STANDARD DEPARTURE CHART-INSTRUMENT

RJFN / NYUTABARU

ILS Y or LOC Y RWY28

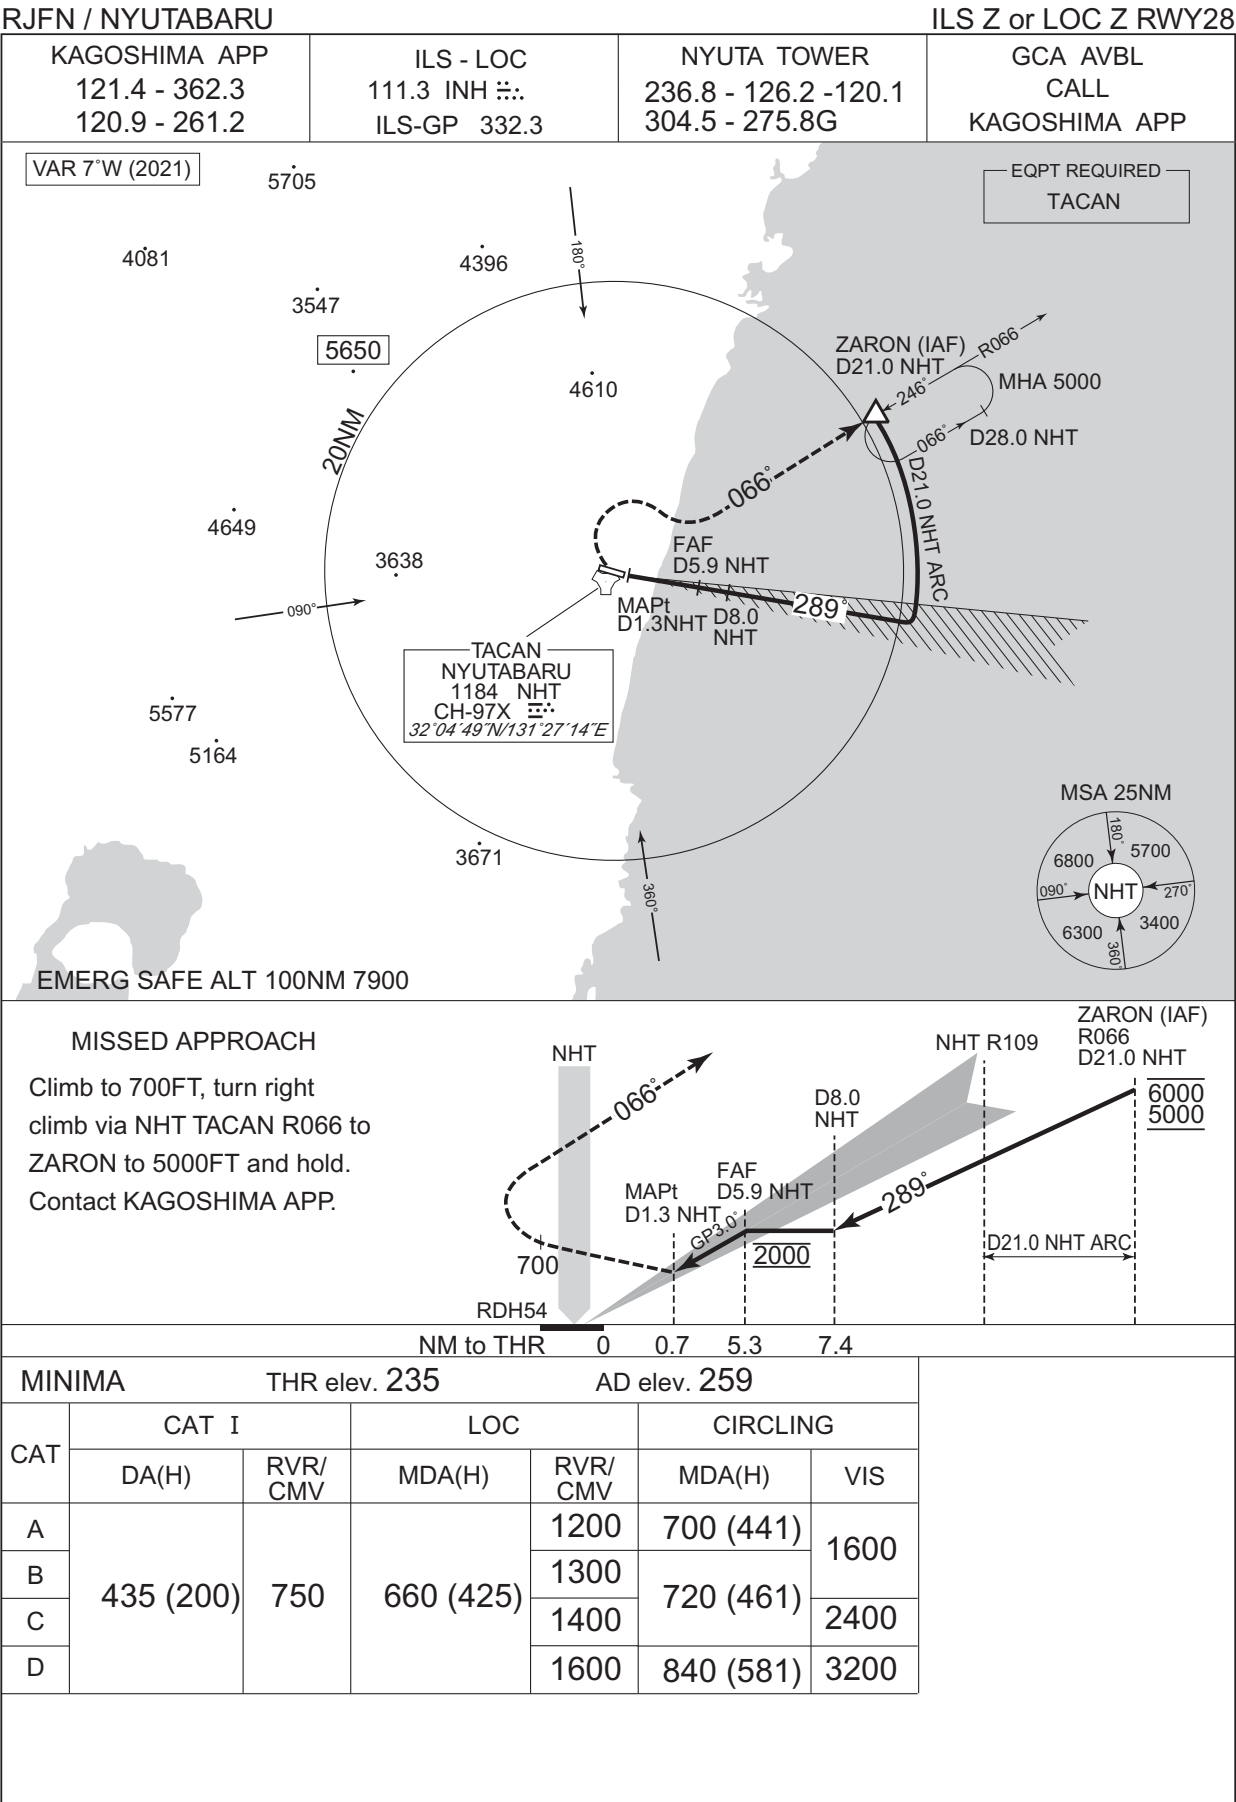
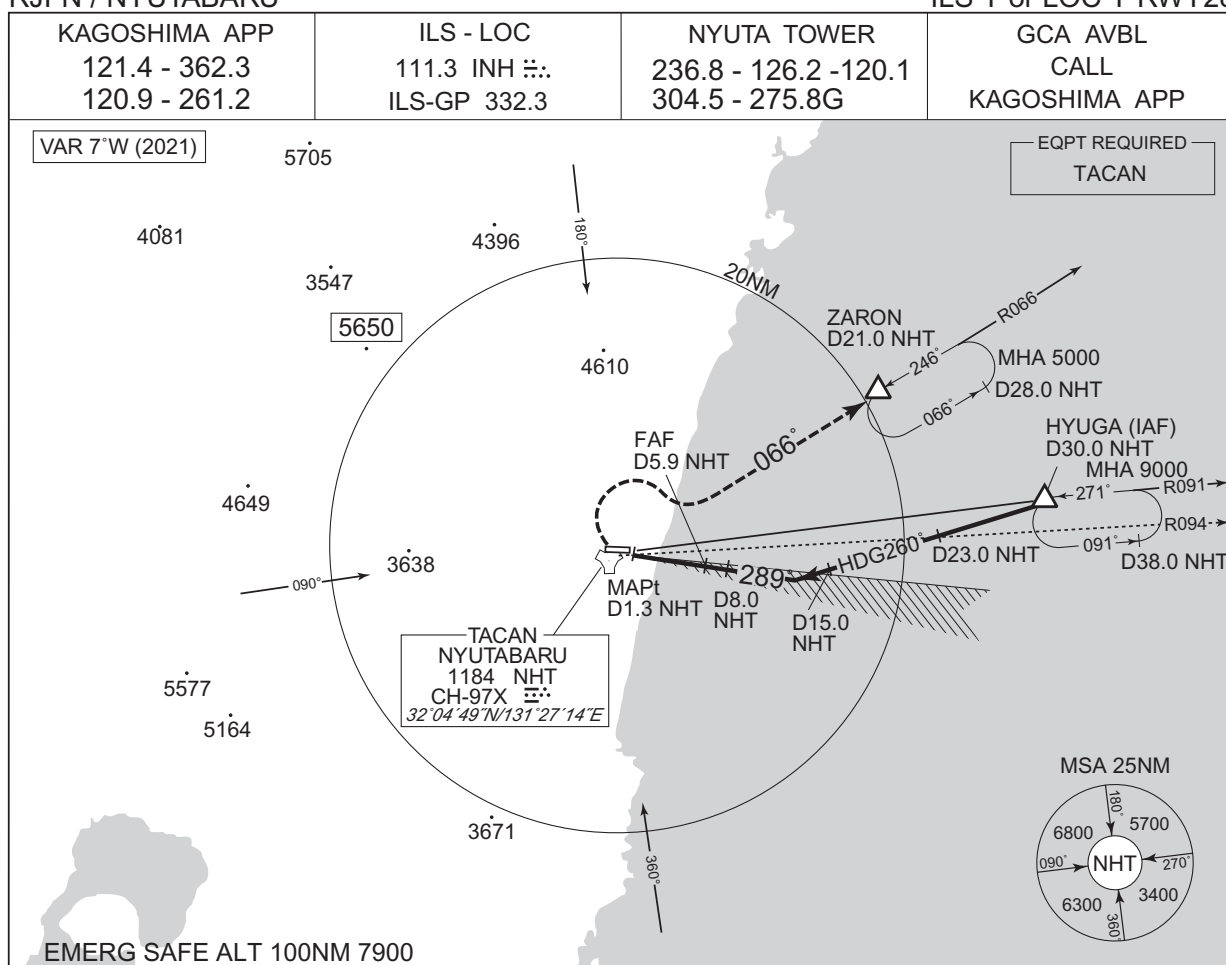
CHANGE : VAR. PROC renamed. EQPT REQUIRED added. PROC course. MISSED APPROACH course. MSA.
NM to THR added. MDA(H) for CIRCLING.
